## HILL VALLEY - PHASE 2B

CITY PROJECT NO. 15860  
CONTRACT NO. 9680

#### REVISION 1 - 04/29/26

#### REVISION 2 - 05/28/26

MARK	REVISION	DATE	BY
15860	Designed By: EEA	Date: 5/28/2026 6:23 AM	Scale: 1" = 40'
U-9

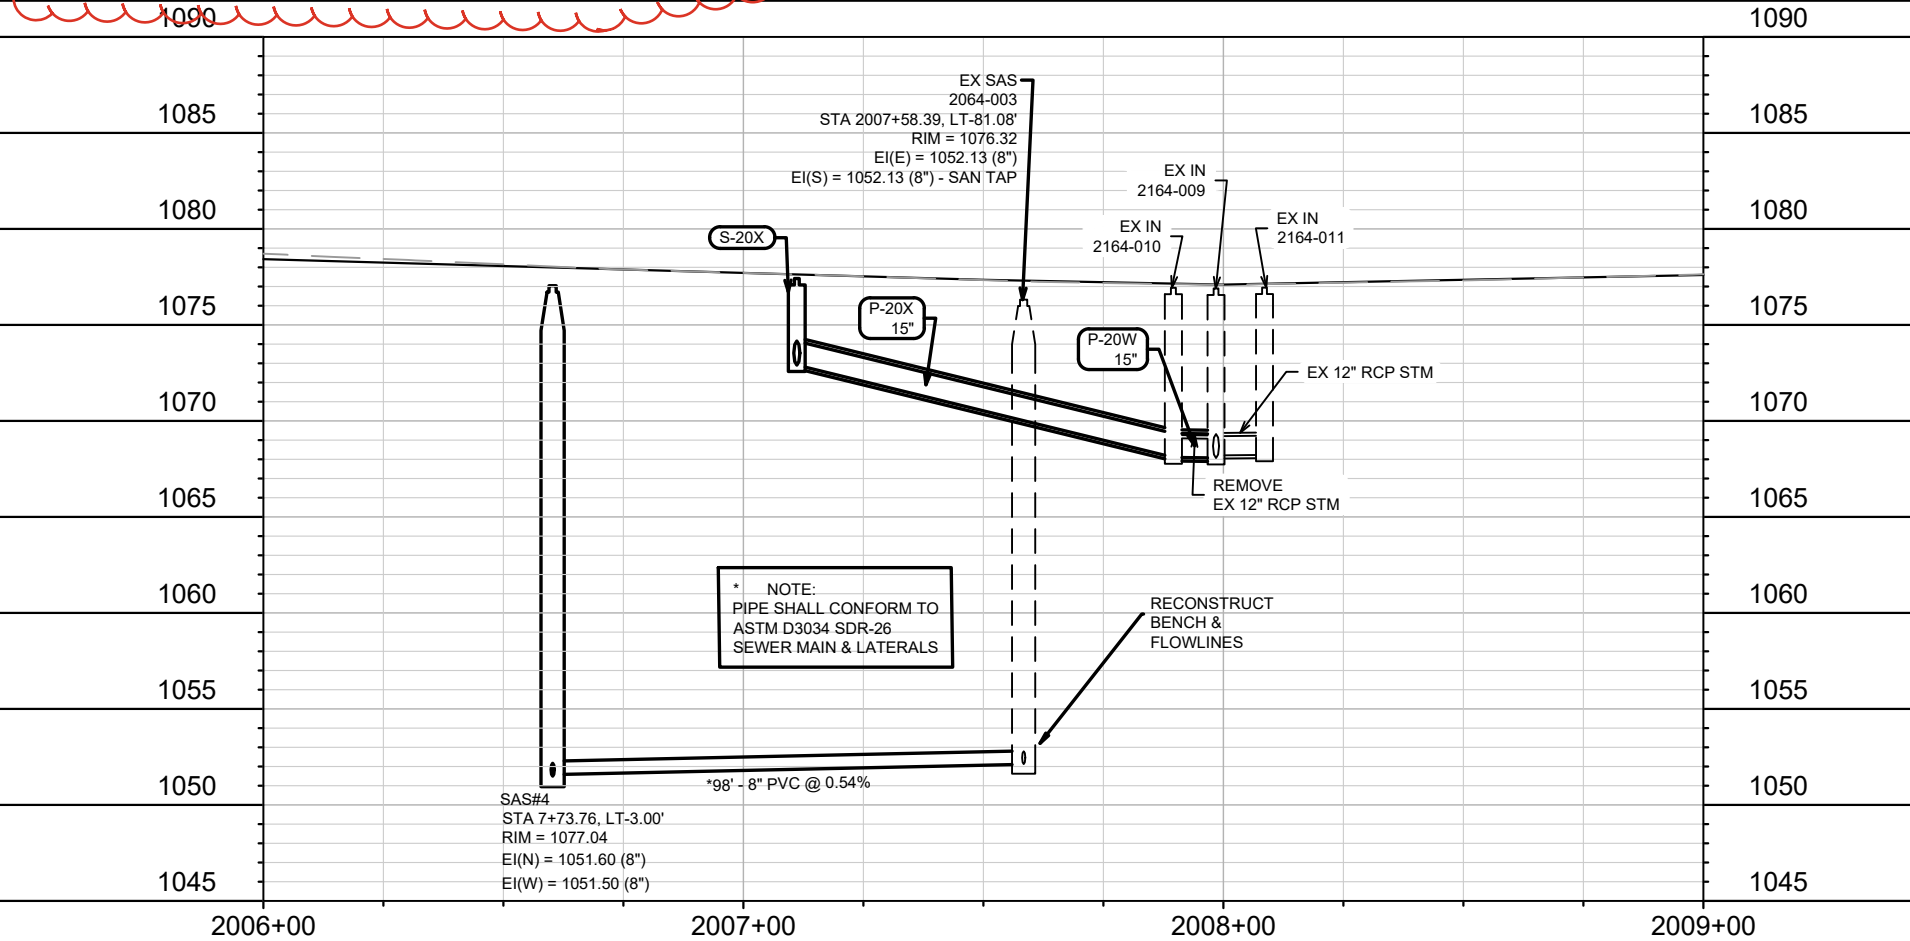
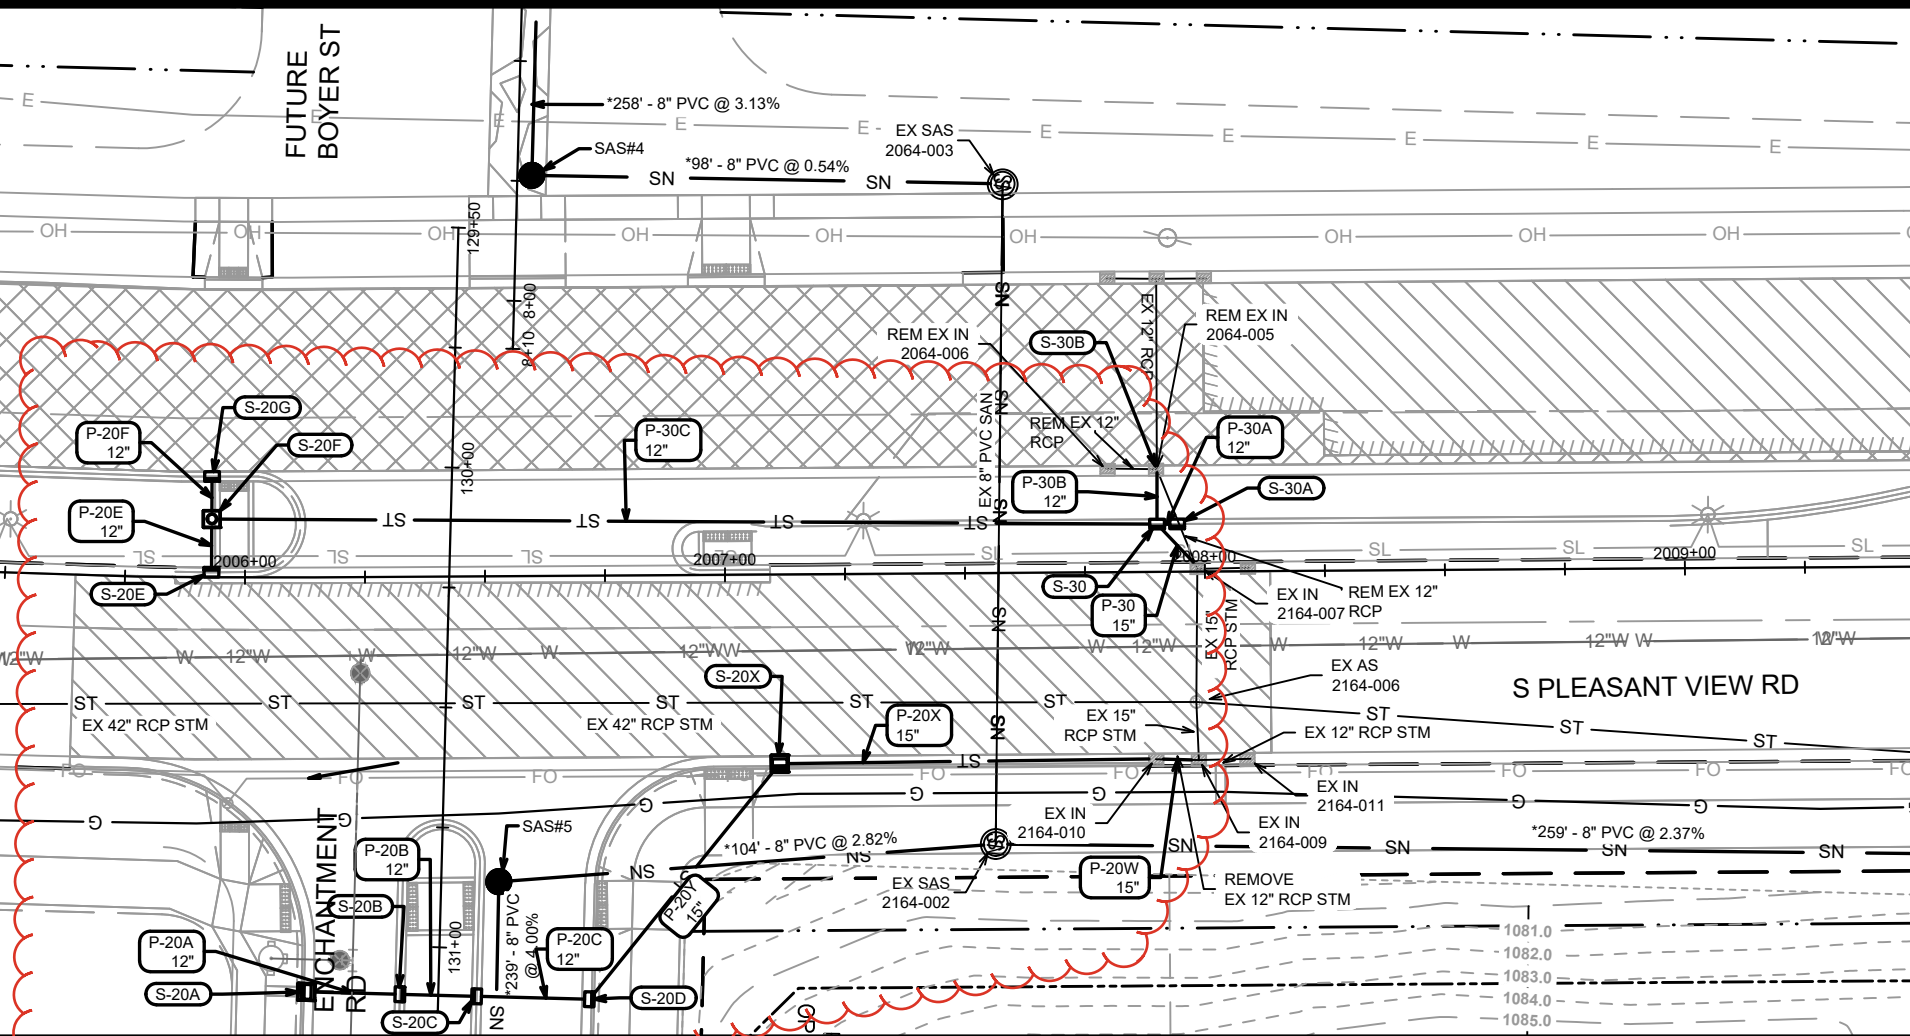
REVISED 5/28/2026 EEA  
 Deleted structure S-20 & pipes P-20 & P-20D on Pleasant View Rd.  
 -Added pipes P-30C, P-20X P-20Y  
 -Added structure S-20X  
 -Revised inverts on structures from S-20A to S-20D

WATER PLAN & PROFILE - ENCHANTMENT ROAD  
 HILL VALLEY - PHASE 2B  
 I:\gisserver\data\DESIGN\Projects\15860\CAD\Water\15860WU-PressureNetwork.dwg

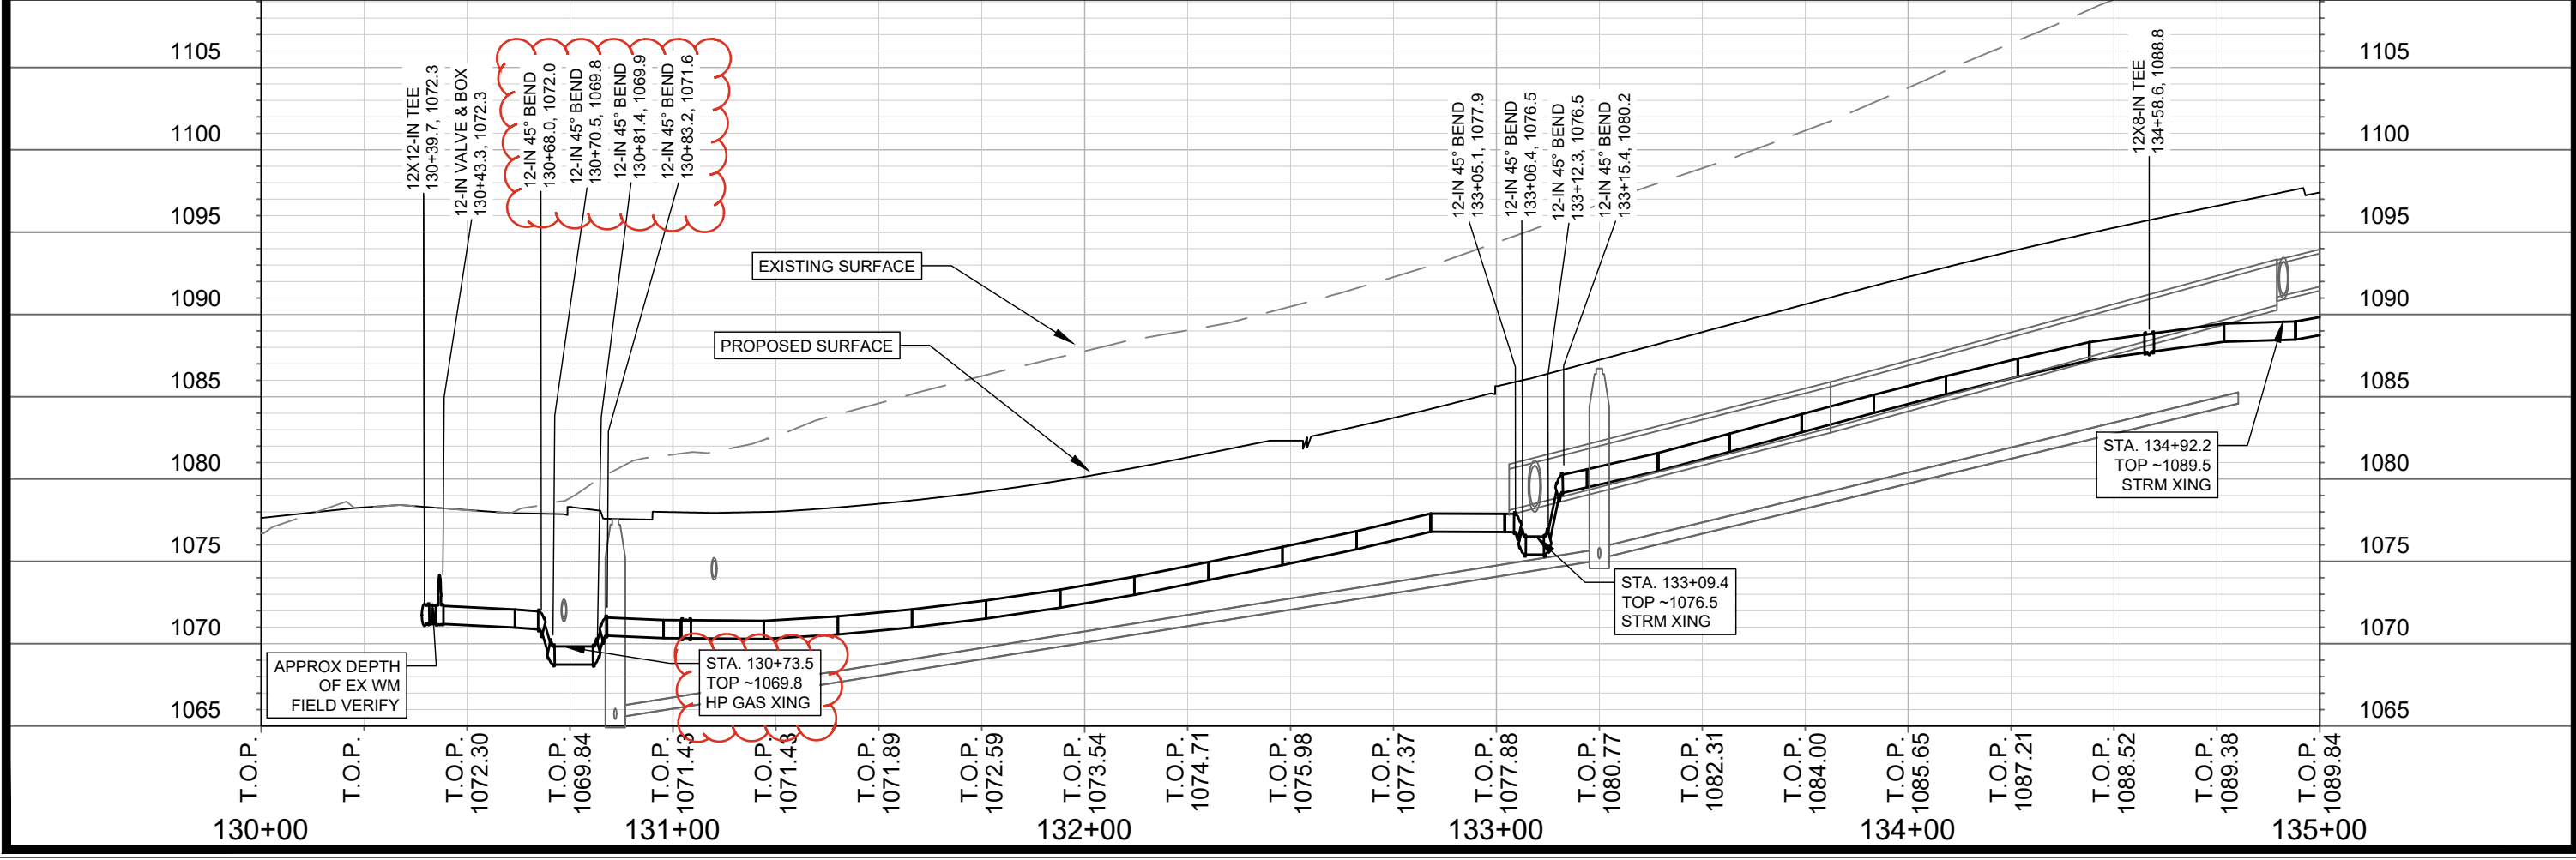
**REVISION 2 5.28.26**  
**REVISED CONNECTION TO EX. 12-IN**  
**ADDED OFFSET AT HP GAS**

WATER PLAN & PROFILE - ENCHANTMENT ROAD  
HILL VALLEY - PHASE 2B  
\\gisserver\data\DESIGN\Projects\15860\CAD\Water\15860WU-PressureNetwork.dwg

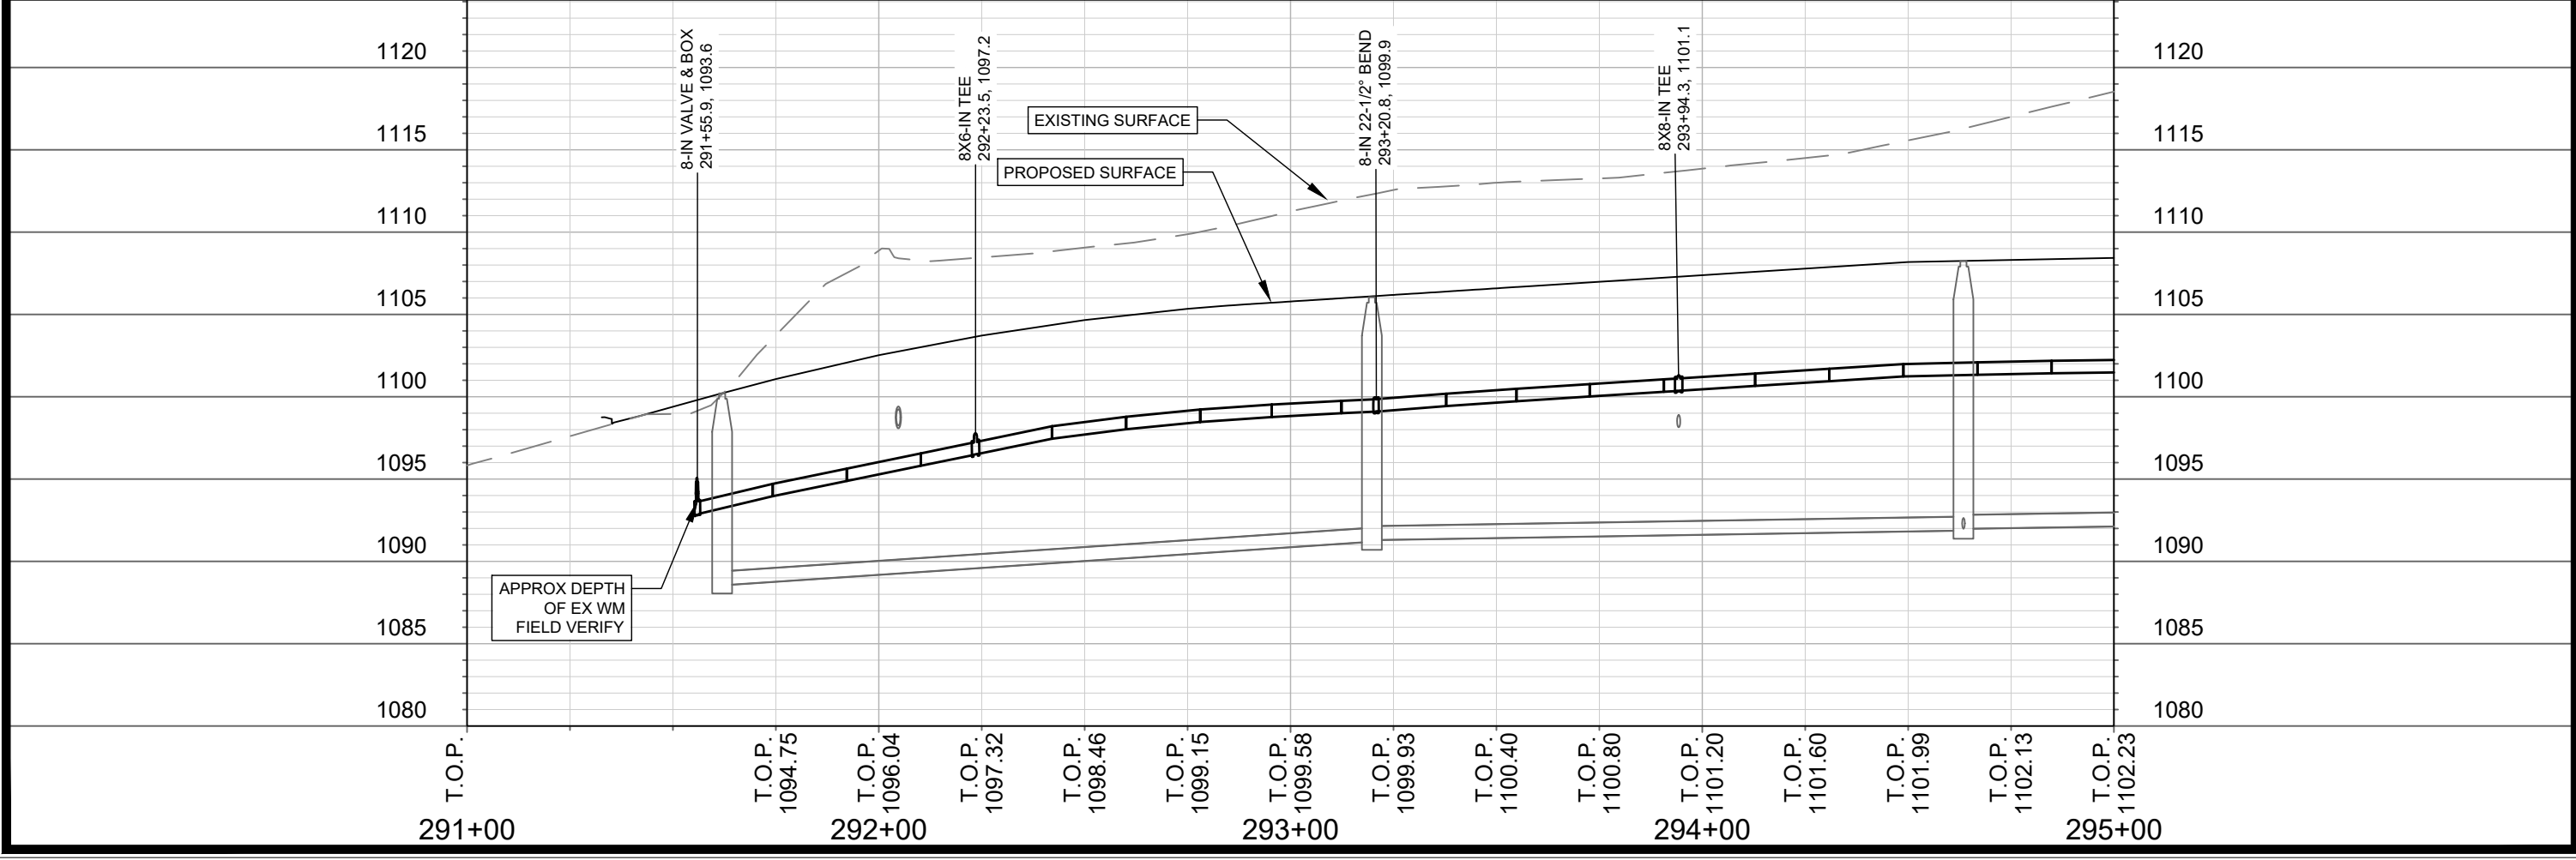
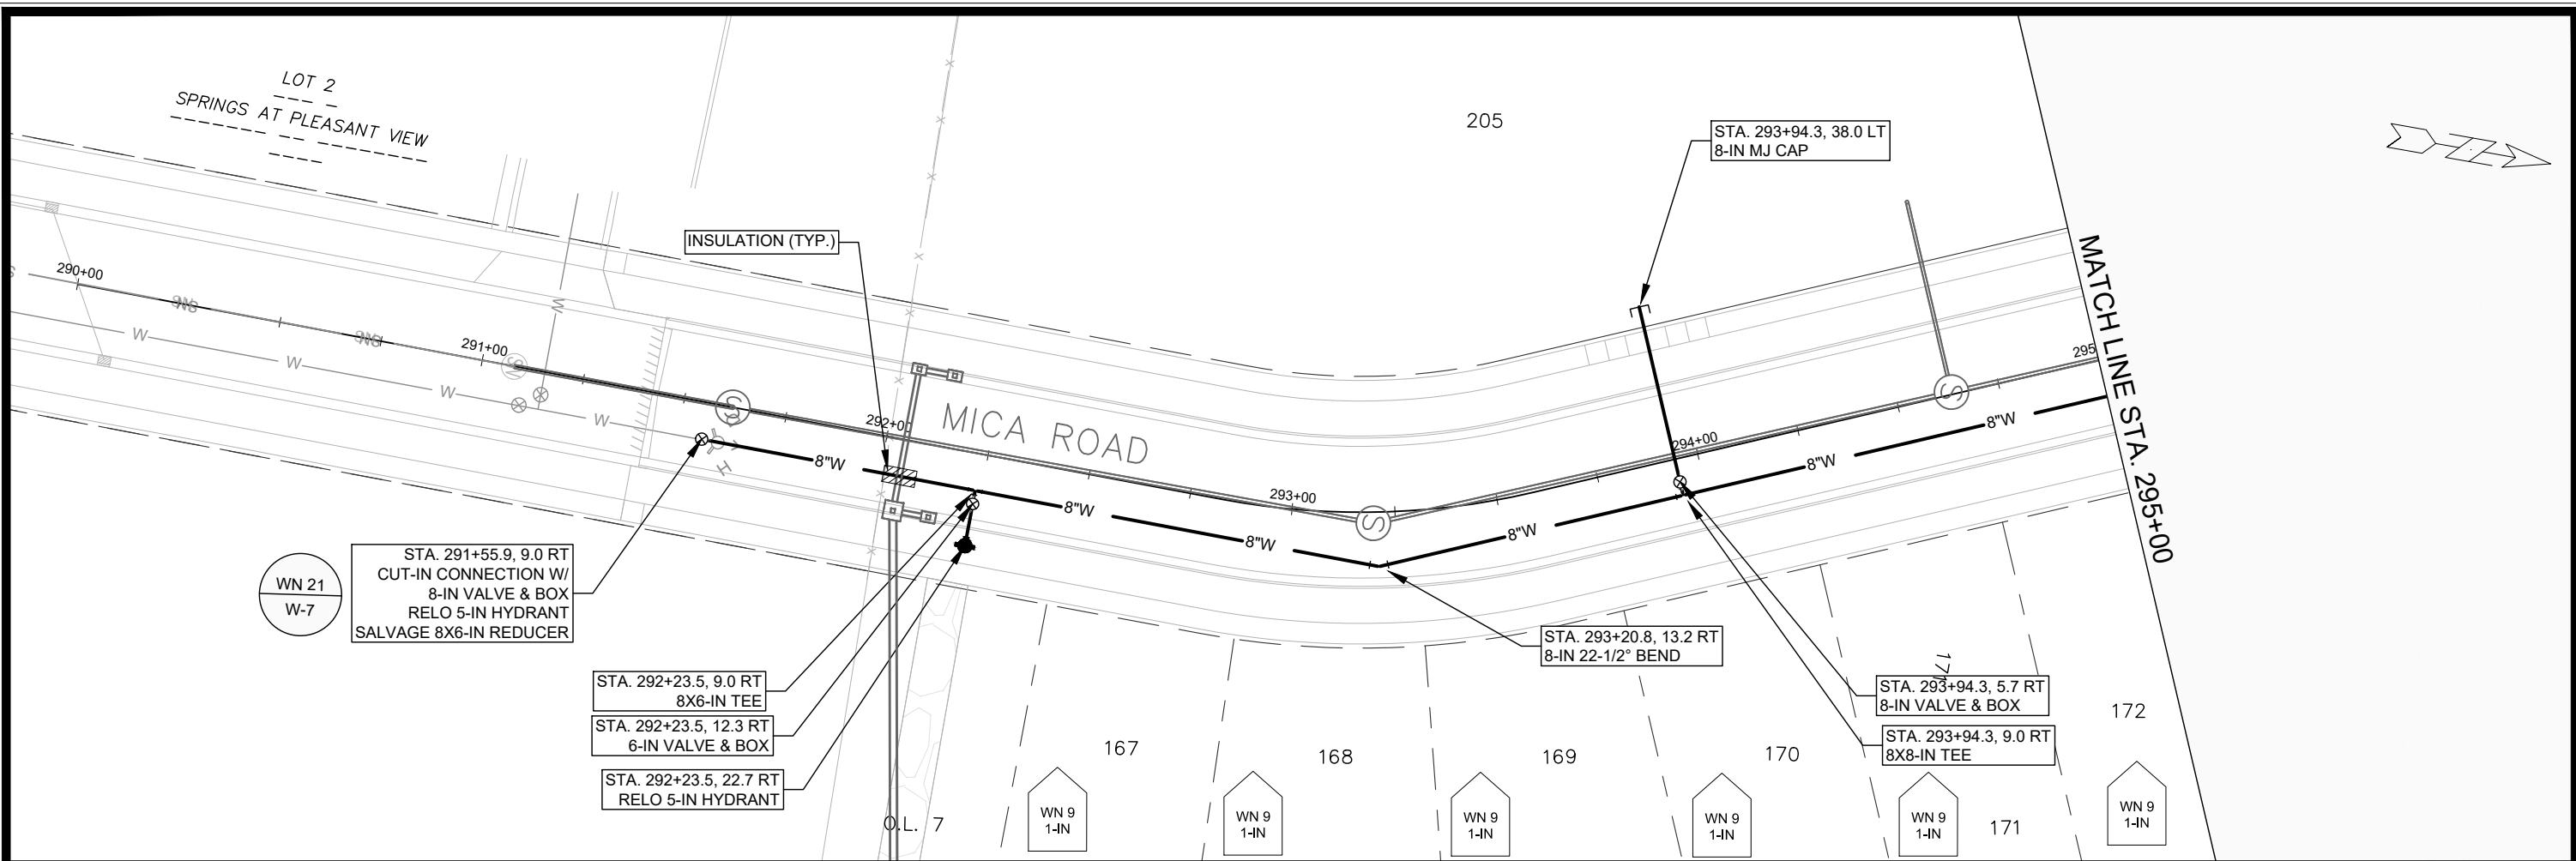
REVISION 2 5.28.26  
REVISED STORM SEWER
